## Proposal for the 02 series of amendments to UN Regulation No. 137 (Frontal impact with focus on restraint systems)

### Submitted by the Working Party on Passive Safety <sup>\*,\*\*</sup>

The text reproduced below was adopted by the Working Party on Passive Safety (GRSP) at its sixty-fifth session (ECE/TRANS/WP.29/GRSP/67, para. 25). It is based on ECE/TRANS/WP.29/GRSP/2020/7 as amended by Annex IX to the report. It is submitted to the World Forum for Harmonization of Vehicle Regulations (WP.29) and to the Administrative Committee (AC.1) for consideration at their November 2020 sessions.

Figure 3

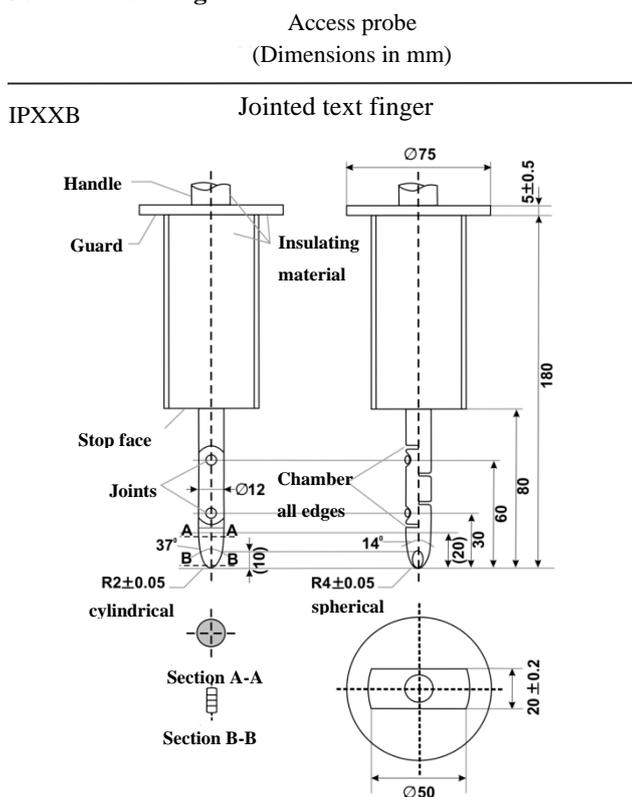
The jointed test finger described in Figure 3 shall be inserted into any gaps or openings of the physical protection with a test force of  $10 \text{ N} \pm 10$  per cent for electrical safety assessment. If partial or full penetration into the physical

The requirements of paragraph 5.2.8.1.3. of this Regulation are met if the jointed test finger described in Figure 3, is unable to contact high voltage live parts.

Figure 4  
Example of the Test Method using DC Power Supply

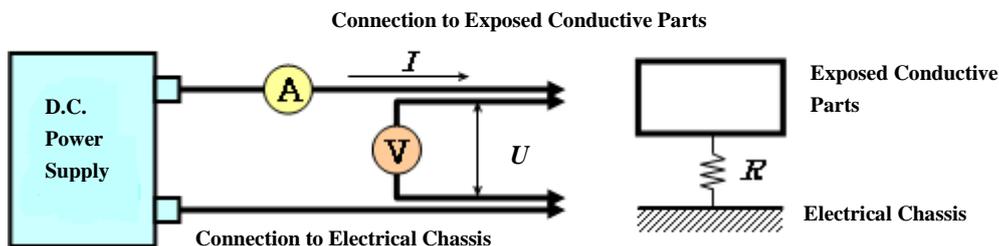
(b) Test method using DC power supply, voltmeter and ammeter.

The DC power supply, voltmeter and ammeter are connected to the measuring points (Typically, electrical chassis and electro conductive enclosure/electrical protection barrier).

The voltage of the DC power supply is adjusted so that the current flow becomes at least 0.2 A.

The current "I" and the voltage "U" are measured.

The resistance "R" is calculated according to the following formula:

The resistance R shall be less than 0.1 Ω.

*Note:* If lead wires are used for voltage and current measurement, each lead wire shall be independently connected to the electrical protection barrier/enclosure/electrical chassis. Terminal can be common for voltage measurement and current measurement.

Figure 5  
Measurement of  $U_1'$

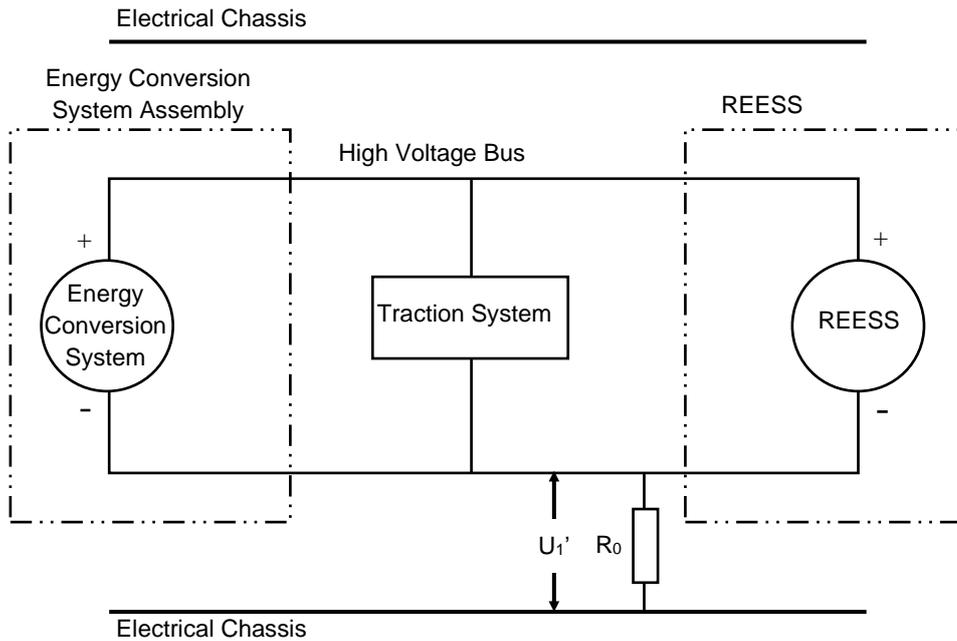
If  $U_1$  is greater than or equal to  $U_2$ , a standard known resistance ( $R_o$ ) is inserted between the negative side of the high voltage bus and the electrical chassis. With  $R_o$  installed, the voltage ( $U_1'$ ) between the negative side of the high voltage bus and the electrical chassis is measured (see Figure 5).

The electrical isolation ( $R_i$ ) is calculated according to the following formula:

Figure 6  
Measurement of  $U_2'$

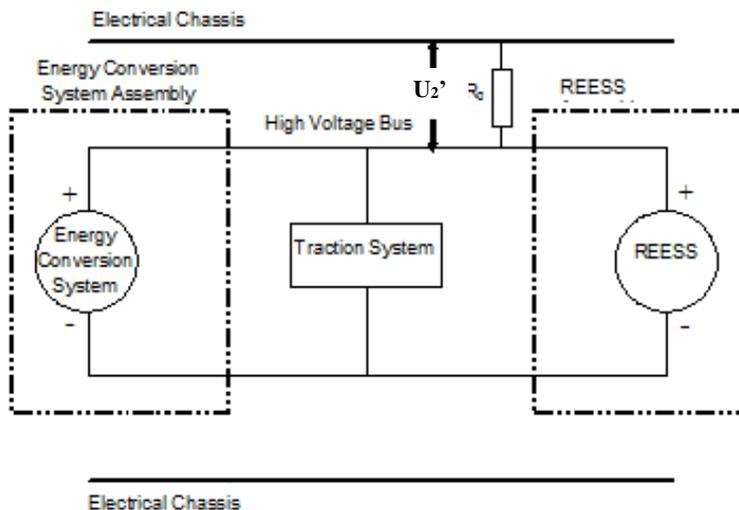
If  $U_2$  is greater than  $U_1$ , insert a standard known resistance ( $R_o$ ) between the positive side of the high voltage bus and the electrical chassis. With  $R_o$  installed, measure the voltage ( $U_2'$ ) between the positive side of the high voltage bus and the electrical chassis (see Figure 6 below). The electrical isolation ( $R_i$ ) is calculated according to the following formula:

$$R_i = R_o * U_b * (1/U_2' - 1/U_2)$$
